Program Bulletin

CUSTOMER SATISFACTION PROGRAM

SUBJECT: Incorrect Front Fascia Grillettes

MODELS: 2014 Cadillac CTS
Equipped with Twin Turbo Engine (LF3)

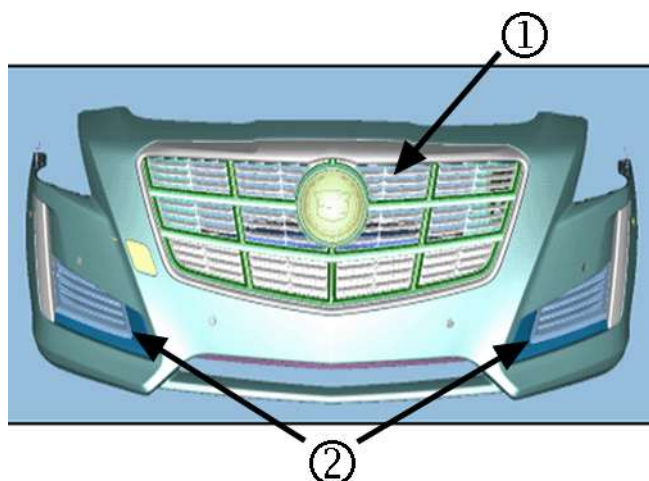
Note: For vehicles with bright chrome grille kits, replace the upper grille (1) and front outer grilles and bezels (2) with the black chrome service parts noted above. For vehicles with black chrome grille kits, replace **ONLY** the front outer grilles and bezels (2) with the service parts noted above.

1. Remove the front upper grille and/or front outer grilles, as necessary. Refer to *Front Grille Kit Installation* in SI.
2. Install the new front upper grille and/or front outer grilles, as necessary. Refer to *Front Grille Kit Installation* in SI.
